Product Change Notification / ASER-05IJPW824

CCB 4556 Initial Notice: Qualification of SIGN as a new assembly site for selected SST39V320xx and SST38VF640xx device families available in 48L TSOP (12x20mm) package.

CCB 4556
Pre and Post Change Summary
PCN #: ASER-05IJPW824

Lead frame Comparison

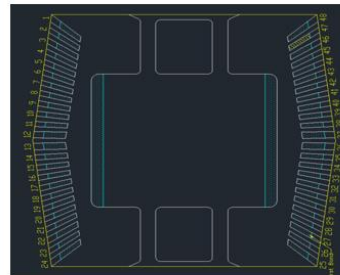
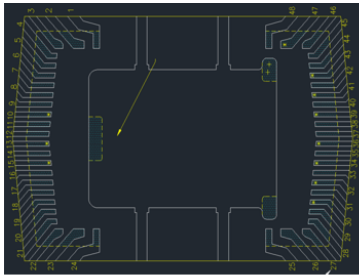
Pre Change		Post Change
Assembly Site	Lingsen Precision Industries, LTD. (LPI)		Signetics Corporation (SIGN)
Wire material	Au		Au
Die attach material	8340		8340
Molding compound material	G700		G700
Lead frame material	C7025		C7025
	See Pre and Post Change comparison attachment.		
Lead frame paddle size	207 x 142 mils	183x161 mils	209x165 mils
DAP surface prep	Ring Plating	Double Ring Plating	Double Ring Plating

LPI

SIGN
